2020/1438/P dated 01/06/2020). This application was necessary as a procedural pre-step to the current s.73 application.

- 2.2 The application seeks to vary condition 2 (approved plans and documents) of the previous scheme, to exchange the plans showing 166 hotel bedrooms, to be changed by internal alterations to become 208 rooms. It also seeks to vary condition 14, which currently stipulates 166 hotel bedrooms, so that it is amended to a maximum of 208 rooms.

Planning Committee

2020/3107/P

Elevation: Adeline Place scale 1:200

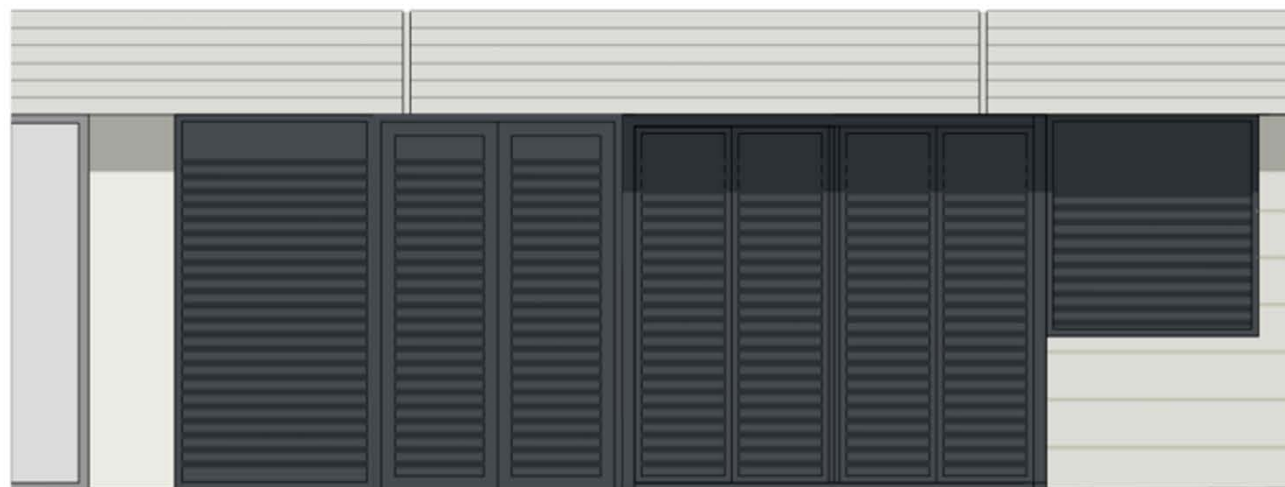
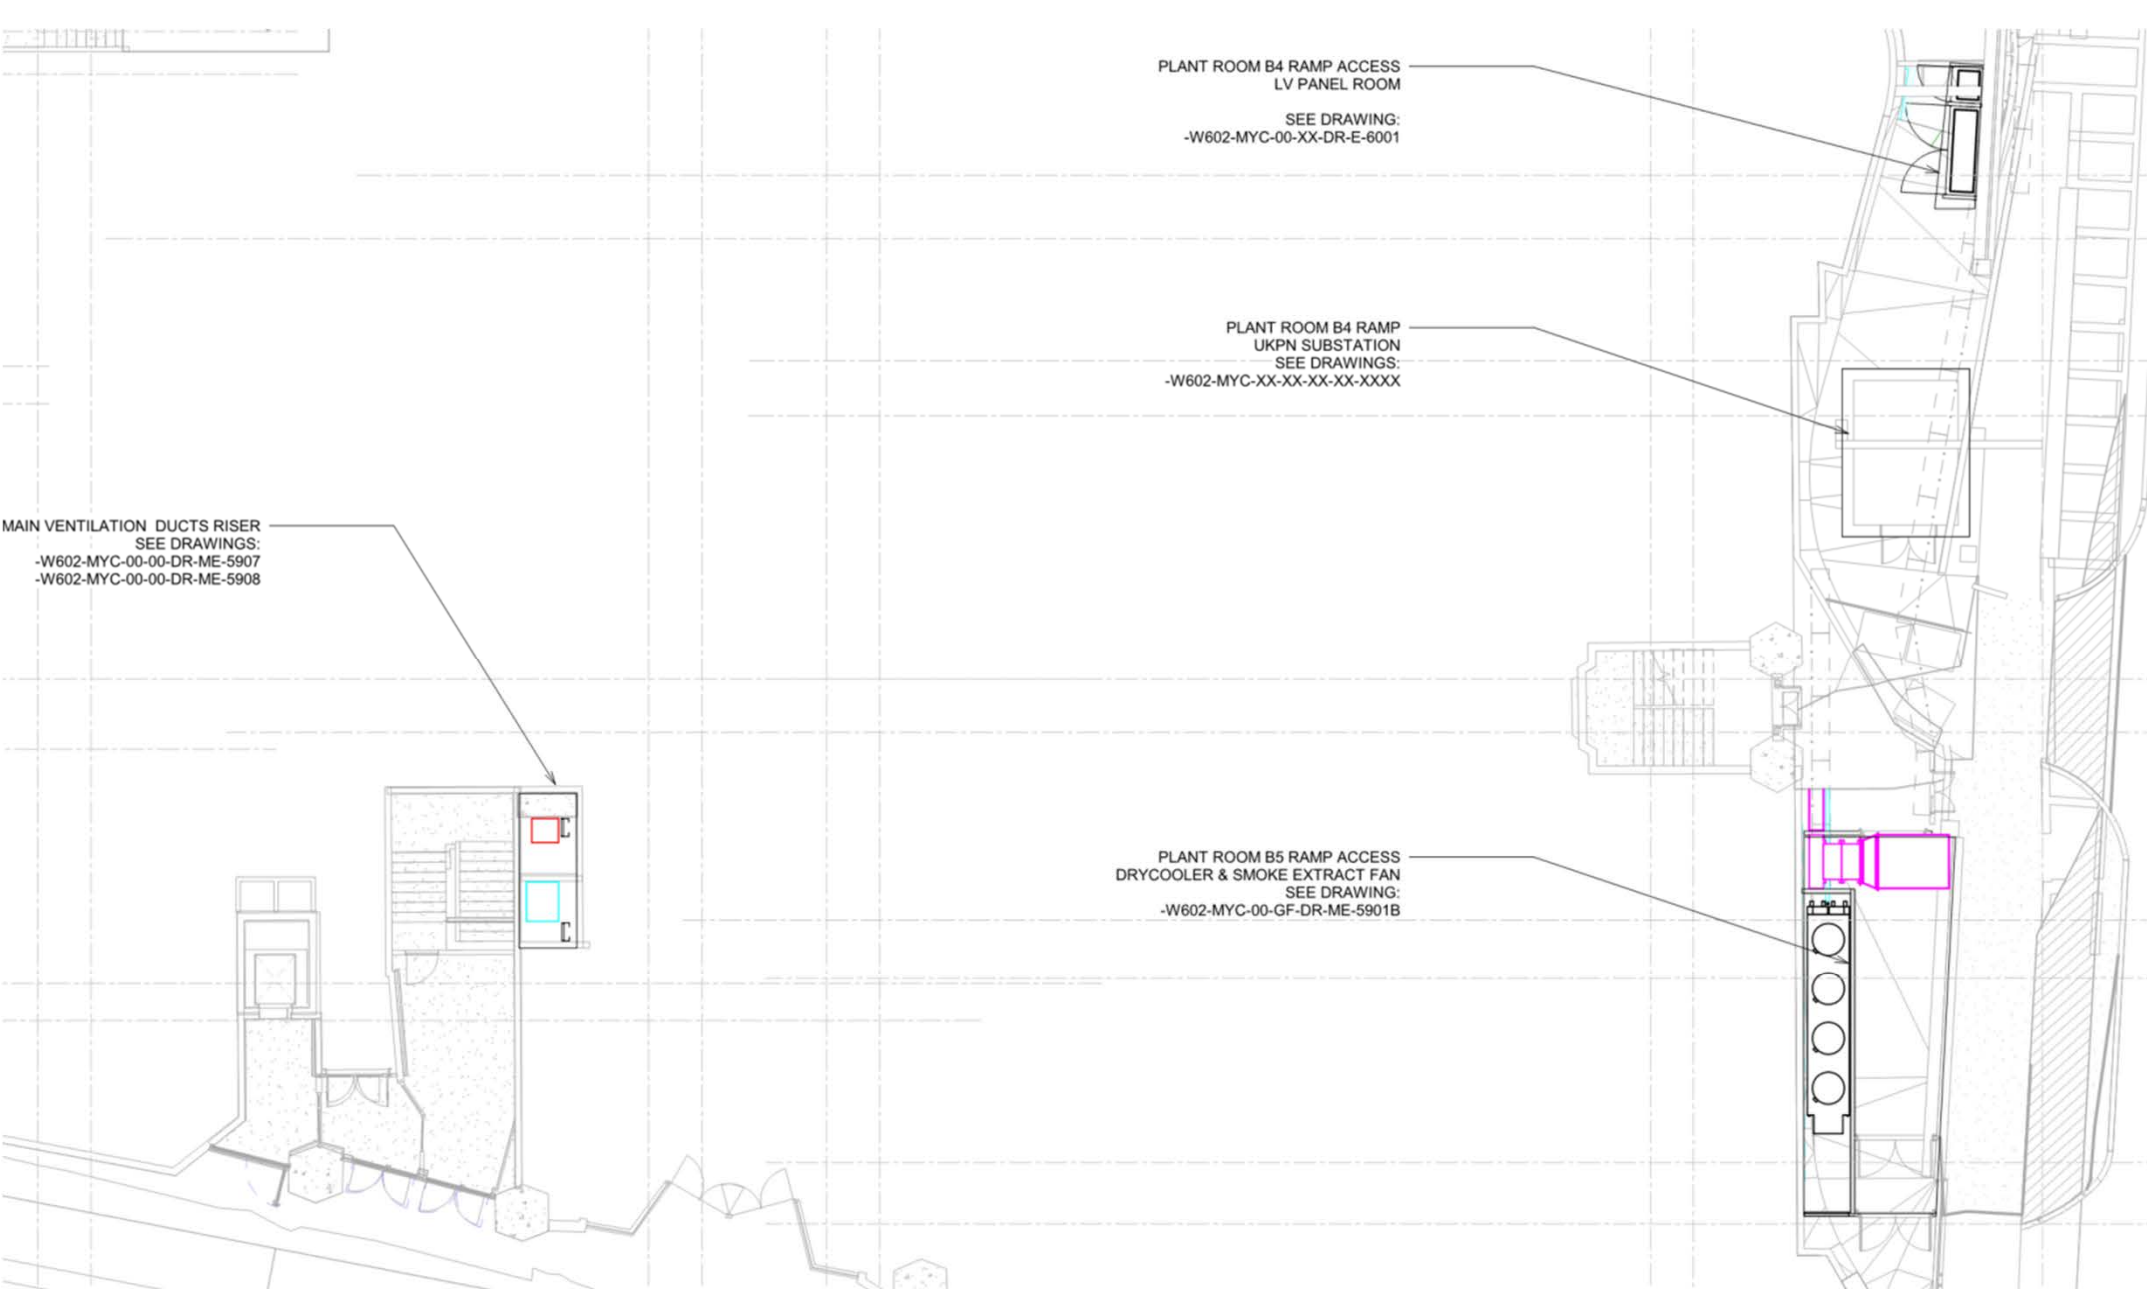
- 5.11 The streetscape will change. The proposed elevation to Adeline Place is particularly unpleasant and threatening. More service activity on Adeline Place will change its character from a 'city street' on the edge of the Bloomsbury Conservation Area to a vehicle intensive 'service road'. That reflects in its architectural expression, which is the very antithesis of an 'active facade', turning a hostile, semi-industrial back to the street in a way that will encourage more drug-related crime and anti-social behaviour than we already experience. This is already evident nearby on Morwell Street and Bainbridge Street, for the same reasons, and must be avoided by designing out rather than encouraging opportunities for crime.

- 5.34 The plant will be bigger and noisier to facilitate the increase in patrons. It's been relocated to Great Russell Street in an elevated position but it is still opposite a residential building. Additional plant is detailed on Adeline Place. No noise or air quality details are given, only a performance specification which fails to consider noise and air leakage through door openings or noise emissions from the substation. Concern about further plant on Adeline Place frontage either shown on the drawings but not addressed in the noise report, or not shown on the drawings but already installed on site. The Bloomsbury Association commissioned its own noise consultant Sandy Brown Associates to represent them at the 2016 appeal. These provided a specification for sound baffling louvres of 300mm depth. The louvres shown on the applicant's elevation drawings do not meet this specification.

Officer Response: The increase in number of hotel rooms on this site (and subsequent servicing activities) does not bring about any significant façade changes to the approved scheme nor will it alter the character of Adeline Place given the previous function of the service access as a ramp for an underground car-park.

Officer Response: The acoustic report submitted with the application addresses the plant most likely to have a noise impact (air handling units on the roof adjacent Great

Russell Street, and the dry coolers and ASHPs on B5 and B4 ramps of Adeline Place). The plant on Adeline Place will all be located behind louvres. The acoustic report provides the noise specification for the louvres which has been approved by Camden Environmental Health officers; but it does not specify materials or thickness for the louvres. The detail shown on the elevation drawings of the louvres is largely indicative in this respect and should the final design contrast materially with that shown then the final details may still be submitted under condition 5 (detailed drawings of external finishes and materials) which remains to be discharged. The required noise thresholds are secured by condition 9 which can enforce the required specification of louvres should it prove necessary. Other plant not shown on the drawings but understood to have been installed on site at the mezzanine level above the Adeline Place basement ramp entrances (kitchen extract flues) appears to be unrelated to this application and is the subject of a separate enforcement investigation.
